Campaign Number: c2046	Revision:	Released Date: 14-Aug-2018
X15 CM2350 X114B/X116B Turbo Actuator Water Intrusion Correction Campaign		Expiration Date (U.S. and Canada): 01-Aug-2020
		Expiration Date (International): 01-Aug-2020

X15 CM2350 X114B/X116B Turbo Actuator Water Intrusion Correction Campaign

Campaign Service Step By Step Repair Process

Loctite 290 Application

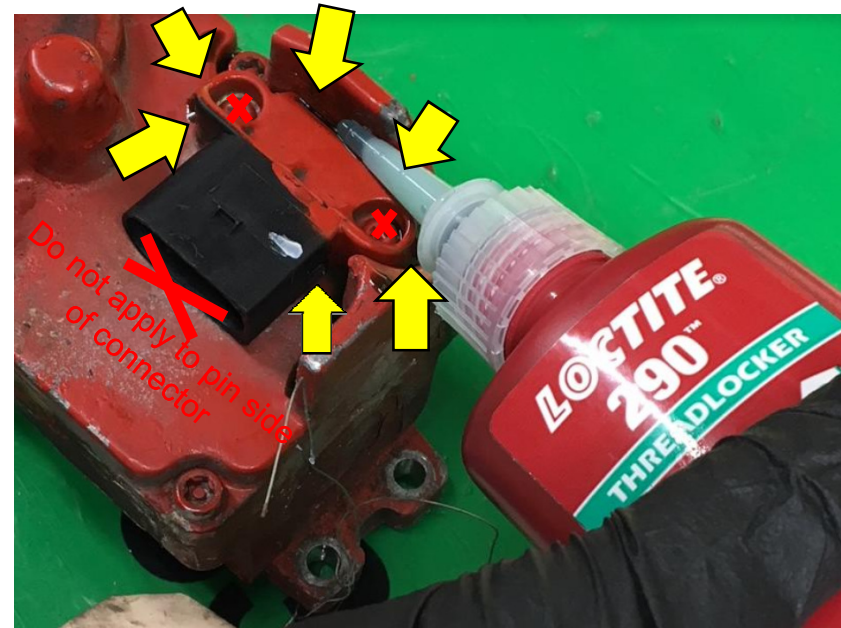
1. Apply a liberal amount of Loctite 290 around the entire black plastic connector body where it meets the aluminum actuator cover.
- DO NOT APPLY TO THE PIN AREA OF THE CONNECTOR.
 - TRY TO AVOID LOCTITE ON THE CAPSCREWS OF THE CONNECTOR.
 - There is time to clean up any excess.
 - The Loctite 290 will wick under the plastic cover and fill any gaps that may lead to a leak path.

Apply Permatex Silicone

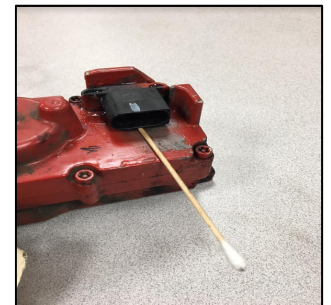
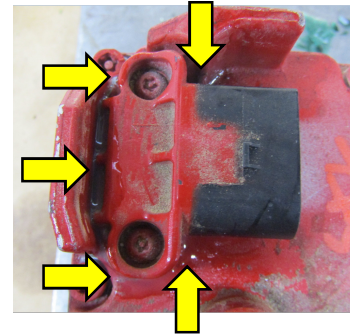
- Apply Permatex silicone around the plastic connector body as shown by arrows
- Apply on the top of the connector mounting screws
- Apply silicone on the edges shown as shown and using a swab stick to smear the silicone underneath the connector to make a thin layer at the VGT actuator connector interface
- Using a white paint marker, apply a witness mark “X” as shown in the picture
- Witness mark confirms the repair has been applied to this actuator

Installation

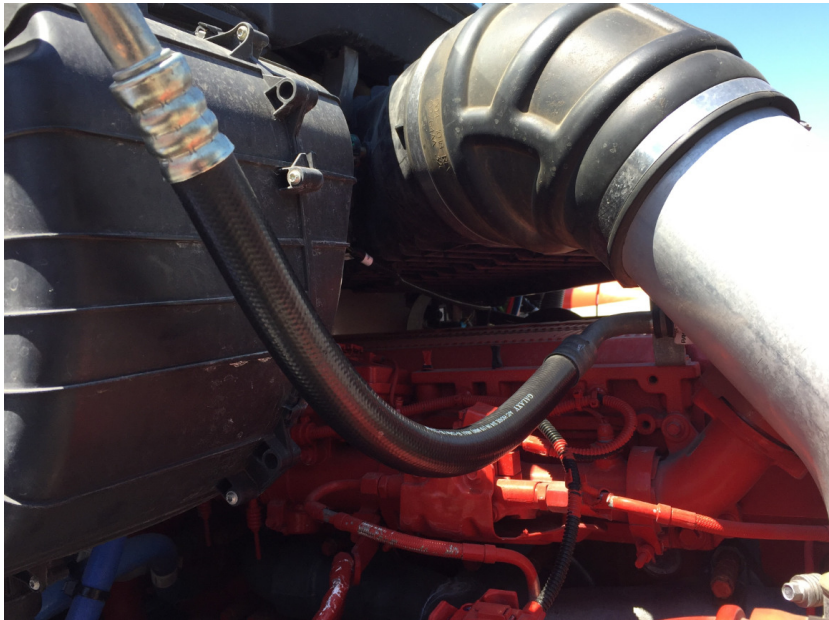
1. Clean Hose – Remove any oil/dirt
2. Wrap Suction Hose with two layers of cross-linked polyethylene insulating foam tape
 - Target 15' (2 ~7.5' sections) of Insulation tape
3. Apply Final wrap to the suction hose with a reflective heat shield tape
 - Target 10' of Thermo-Shield Wrap
4. Secure the wrap in place using two zip ties on each end of the wrap
 - Target 2' inches from the end
5. Make sure the tail of the zip tie is pointed towards the ground as pointed out
